S	TM MH'S	STM MH'S	
МН	Details	MH Details	
	RIM EL = 8.02 1200mmø	$ \begin{array}{c ccccccccccccccccccccccccccccccccccc$	γ
12	INV (SW) = 5.88 INV (SE) = 5.89	1 1 1 1 1 1 1 1 1 1 1 1 1 1 1 1 1 1 1	
	INV (W) = 6.71 INV (S) = 5.85	$INV (W) = 6.47$ $INV (N) = 6.44$ $208 \frac{RIM EL = 9.52}{???mm^{\emptyset}}$ $INV (W) = 8.98$ $INV (W) = 8.98$ $INV (W) = 0.00$ $IV (W) = 0.00$ $IV (W) = 0.00$	
	INV (N) = 5.84 RIM EL = 11.79	$\begin{array}{c c} \hline \\ \hline \\ 208 \end{array} \begin{array}{c} \text{RIM EL} = 9.52 \\ ???mm \emptyset \end{array} \begin{array}{c} \hline \\ \hline \\ \end{array} \begin{array}{c} \hline \\ \\ \end{array} \begin{array}{c} \hline \\ \\ \end{array} \begin{array}{c} \hline \\ \\ \\ \end{array} \begin{array}{c} \hline \\ \\ \\ \end{array} \end{array}$	
101	$600 \text{mm}\phi$ INV (SE) = 11.04	1000 INV (W) = 8.98	Parkade Footprint
	RIM EL = 13.35		(Blue Line)
102	$600 \text{mm} \phi$ INV (NW) = 10.90

ISSUED FOR CONSTRUCTION

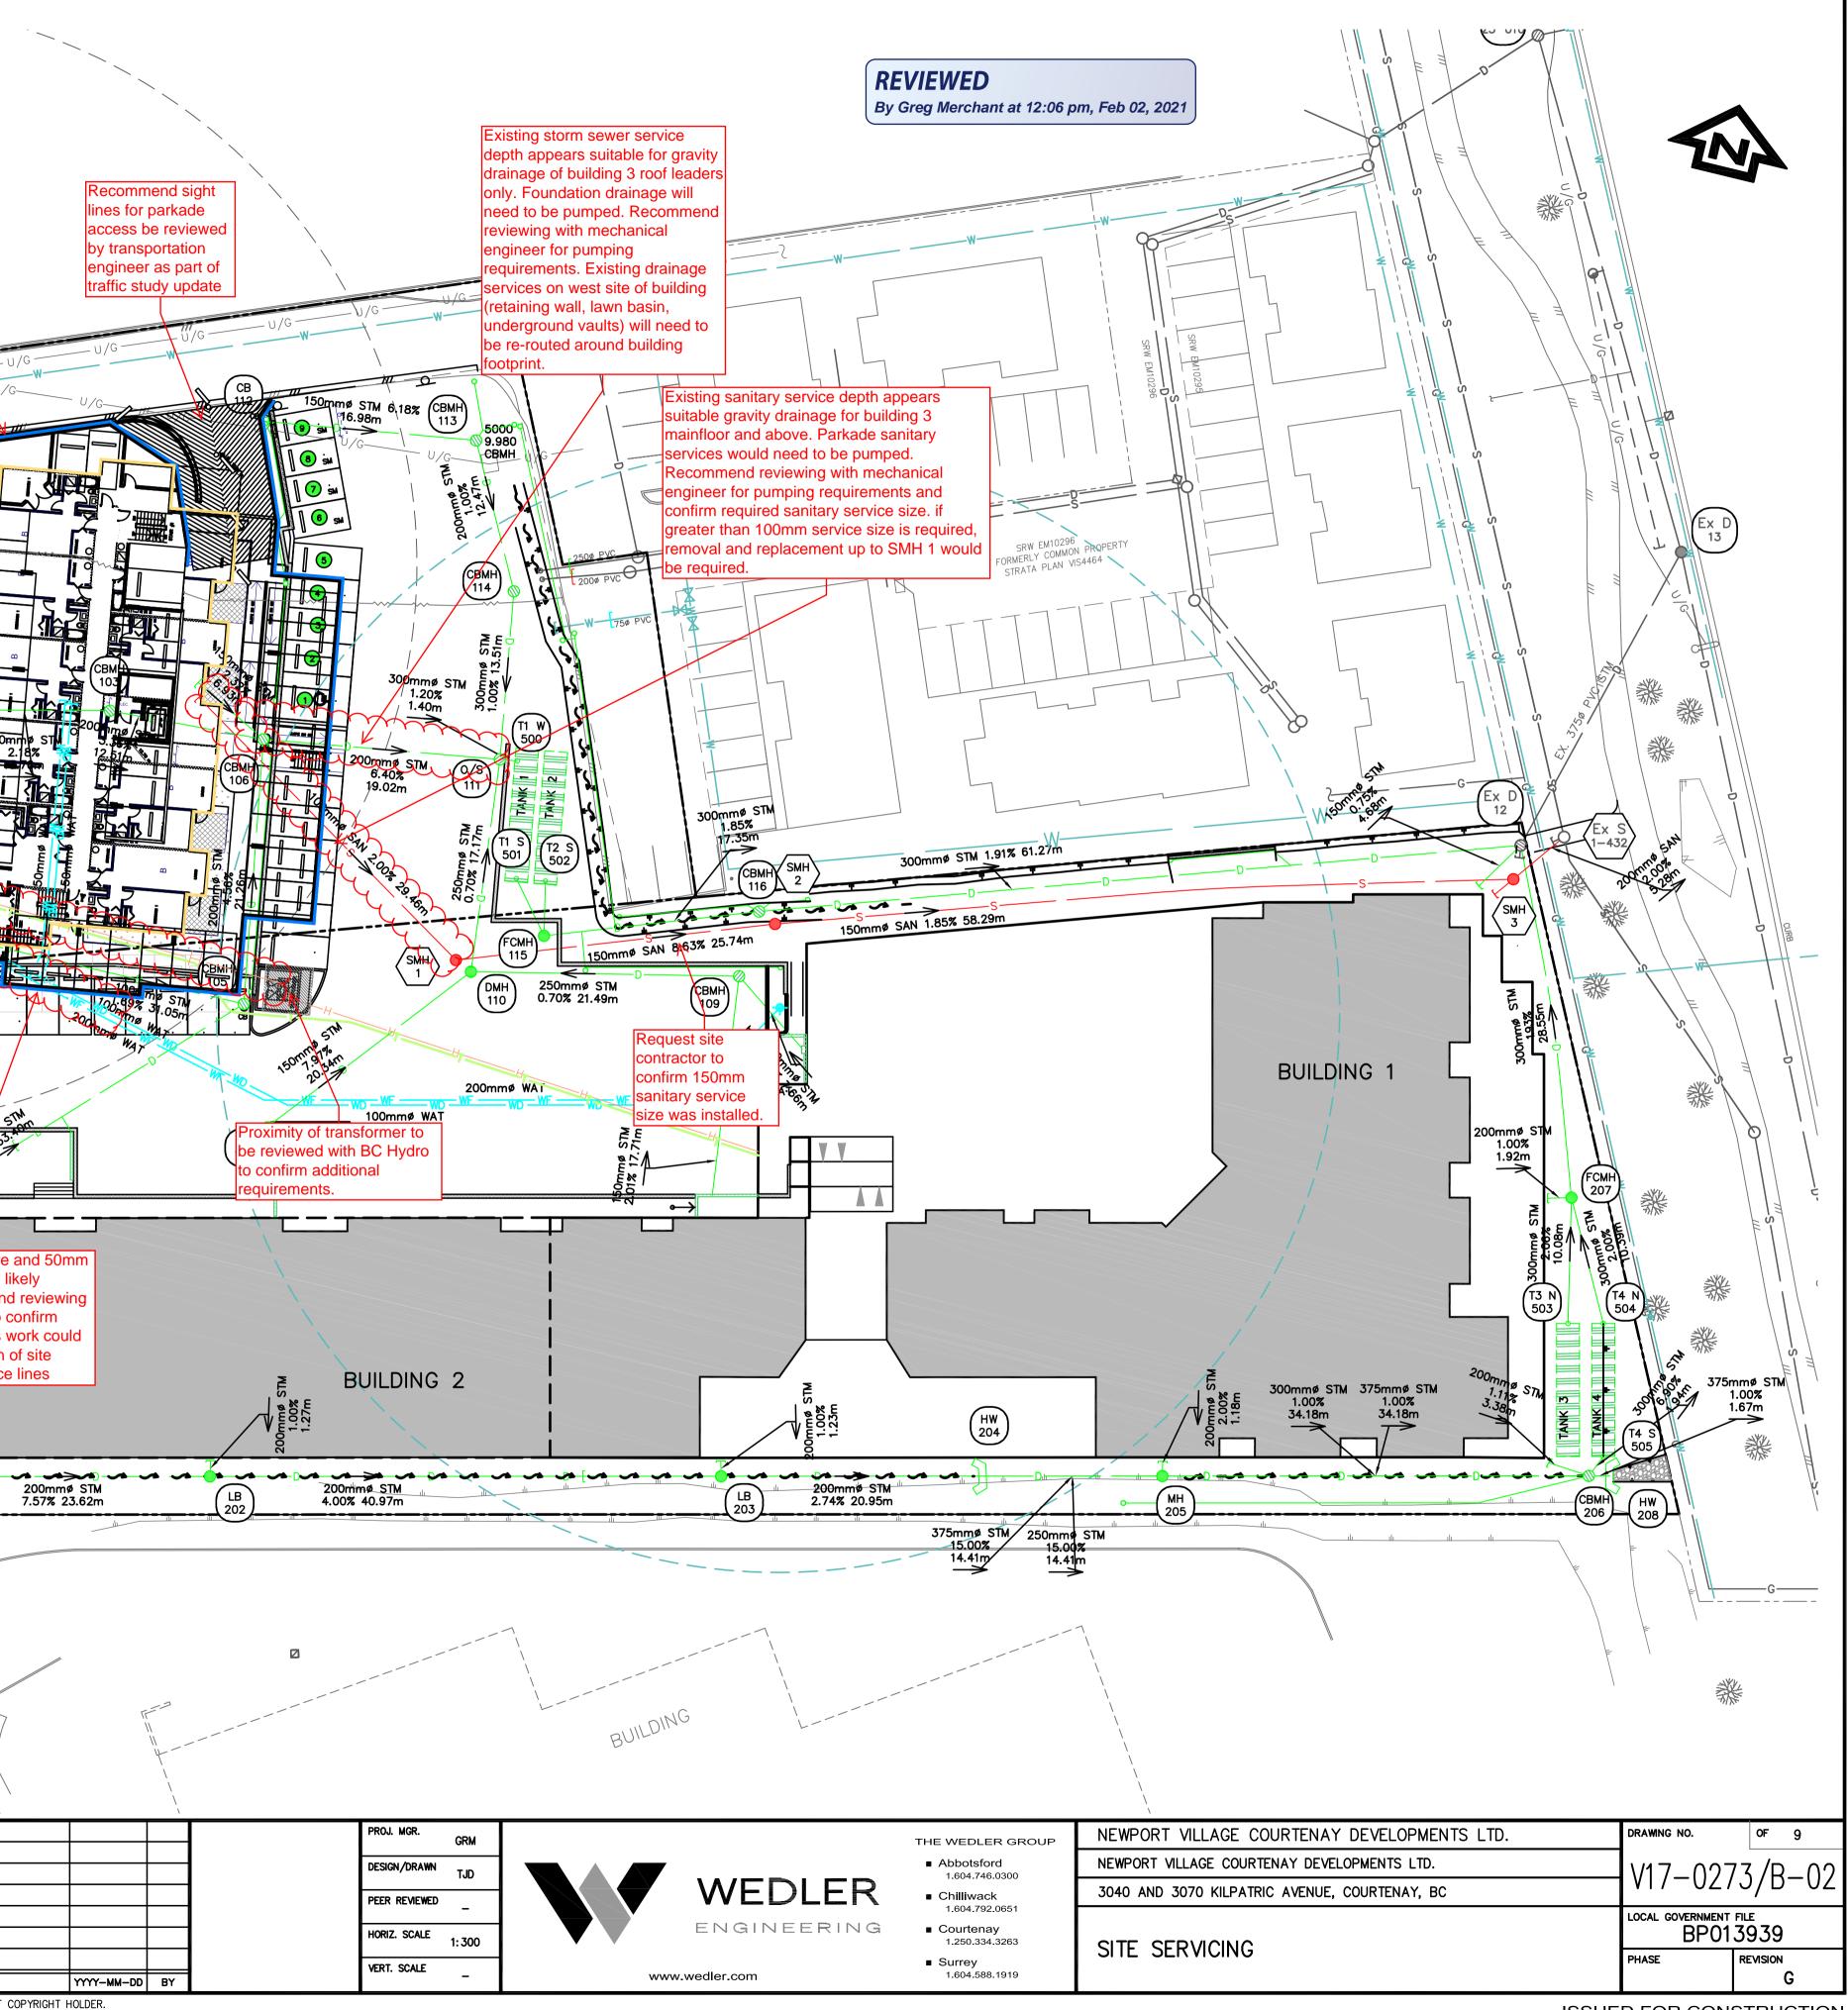
INV (E) = 10.87 RIM EL = 11.93		or Footprint Line)
103	1050mmø		M
	INV(E) = 10.52		U/GUU/G-
104	RIM EL = 12.85 600mmø		
-	INV (NE) = 12.10 RIM EL = 12.24		
105	1050mmø INV (SW) = 11.14	30TH Existing drainage on west side	
	INV (W) = 11.05 INV (N) = 11.00	of building 3 will need to be re-	
	RIM EL = 11.25 1050mmø	S routed around south side to building.	
106	INV (S) = 10.03 INV (W) = 10.10	SAN MH'S	7.51
	INV (W) = 10.10 INV (NW) = 10.15 INV (E) = 10.00		
	RIM EL = 10.69	RIM EL = 11.35 1050mmø	
107	1050mmø INV (N) = 9.58	S1 $1000000000000000000000000000000000000$	
	RIM EL = 10.17 1050mmø	RIM EL = 7.94	Letter I
109	INV (S) = 9.23 INV (SE) = 9.10	S1-432 S1	
	INV (W) = 9.05	INV (NW) = 5.18 conflict with Building 3. Recommend surveyor	102 150mm
	RIM EL = 11.32 1050mmø INV (E) = 8.90	RIM EL = 9.53 1050mmø = = 1 S2 RIM EL = 9.53 1050mmø = = 1	
110	INV (E) = 8.90 INV (SW) = 8.90 INV (N) = 8.87	S2 $INV (W) = 7.74$ INV (E) = 7.69 relocated which will require shut down of power	3.00

RIM EL = 10.70	RIM EL = 8.09 and communications to the site. Relocation may I200mmø present a challenge due to rerouting of water	
111	1050mmø INV (S) = 8.75	S3 INV (SW) = 5.39 INV (W) = 6.59	1.13
	INV (N) = 8.57 INV (W) = 8.78 INV (E) = 8.57	INV (NE) = 5.34	
	RIM EL = 10.65		
112	$600mm\phi$ INV (E) = 9.90	Existing site fire and domestic waterline appear in conflict with building footprint.	Rolling
	RIM EL = 9.97 1050mmø	Recommend having surveyor confirm	
113	INV (W) = 8.85 INV (SE) = 8.84	location. Likely these lines will need to re-routed along the south side of	
	RIM EL = 10.43 1050mmø	building.	
114	INV (NW) = 8.72 INV (S) = 8.71		
	RIM EL = 11.20		
115	1500mmø INV (NW) = 8.22 INV (N) = 8.22		0100
	INV (N) = 8.22 INV (E) = 8.22		T 1 28/70
116	RIM EL = 9.24 1050mmø		
110	INV (W) = 7.90 INV (E) = 7.88		
117	RIM EL = 11.71 600mmø		xisting Building 3 50mm fire a
	INV (NE) = 10.52 RIM EL = 16.18		lomestic water service may like equire upsizing. Recommend r

201	INV (E) = 15.31		vith mechanical enigneer to co equired service sizing. This wo
	RIM EL = 14.43		e done at time of relocation of
202	600mmø INV (W) = 13.52 INV (N) = 13.56		rimary water and fire service li
	INV (E) = 13.52		5
	RIM EL = 12.91 1050mmø		
203	INV (W) = 11.88 INV (N) = 11.92 INV (E) = 11.88		
	RIM EL = 12.30		
204	INV (W) = 11.31		
	T:INV (E) = 11.31 T:INV (E) = 11.76		
	RIM EL = 10.67 1050mmø		SDE
205	T: INV (W) = 9.15 INV (N) = 8.93		
375 OUTLE	T: INV (W) = 9.60 T: INV (E) = 9.34		
	F:INV (E) = 8.85 RIM EL = 9.68		
375 INLE	1200mmø T:INV (W) = 9.00		
	F: INV (W) = 8.30 T: INV (W) = 8.51		SIDEWALL
	INV (NE) = 8.20 INV (E) = 9.00		
1504			
LEGAL:	OT B, PLAN VIP814	A ISSUED FOR DEVELOPMENT PERMIT 2017–11–08 GRM 460 B ISSUED FOR BUILDING PERMIT 2017–12–15 TJD	
	DT 3, PLAN VIP354	5438 C RE-ISSUED FOR BUILDING PERMIT 2018-04-20 TJD	
		D ISSUED FOR TEMBER 2018-05-14 TJD E ISSUED FOR CONSTRUCTION 2018-06-08 TJD
